TSB 21-007-06

RFE Transmission Filters - Delayed Engagement And Related Transmission DTC'S

Date: April 07, 2006

Models: 2005 - 2006 (DR) Ram Truck

FIGURE 2 - Transmission Filters - 4X4 Shown

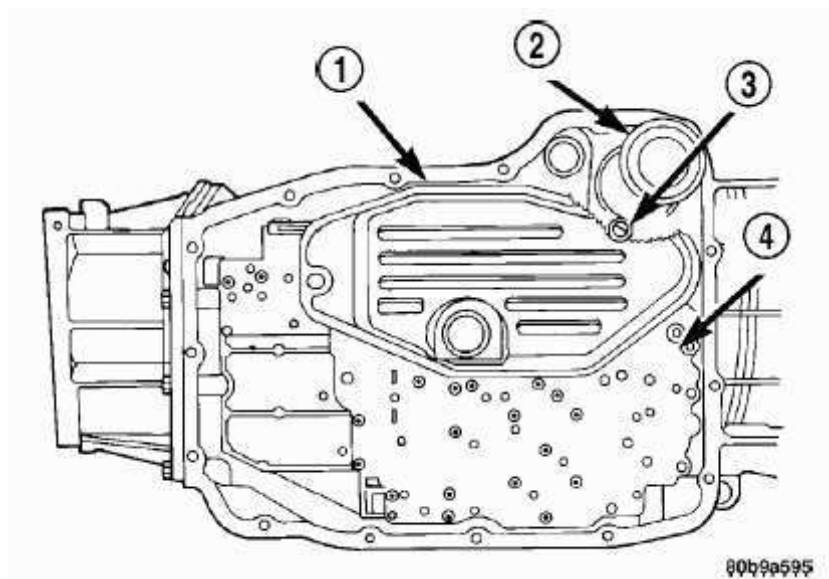
NOTE: All cooler return filters with the “AB” suffix (04799662AB) are suspect. The above condition may be corrected by replacing a suspect “AB” filter with a new cooler return filter whose part number is 04799662 (with no suffix or with a suffix that is other than the “AB” level), and a new sump filter.

NOTE: BOTH the sump oil filter and the cooler return filter MUST BE replaced in the transmission at the same time. Do not replace one filter without also replacing the other filter.

NOTE: A replacement 04799662 cooler return filter may come packaged with a separate threaded adapter stud. The threaded adapter stud is used to attach the cooler return filter to the transmission. Inspect the stud and note end without threads. Install the stud end without the threads into the cooler return filter and tighten the stud-to-filter connection to 18.6 Nm (165 in. lbs.). Once the threaded adapter stud has been installed to the cooler return filter, install the assembled cooler return filter to the transmission and tighten the filter to 14.1 Nm (125 in. lbs.)

NOTE: Always install the sump filter seal to the bottom of the transmission oil pump first, then install the sump filter to the oil pump and previously installed seal. DO NOT install the sump filter seal to the sump filter and then attempt to install both to the oil pump.
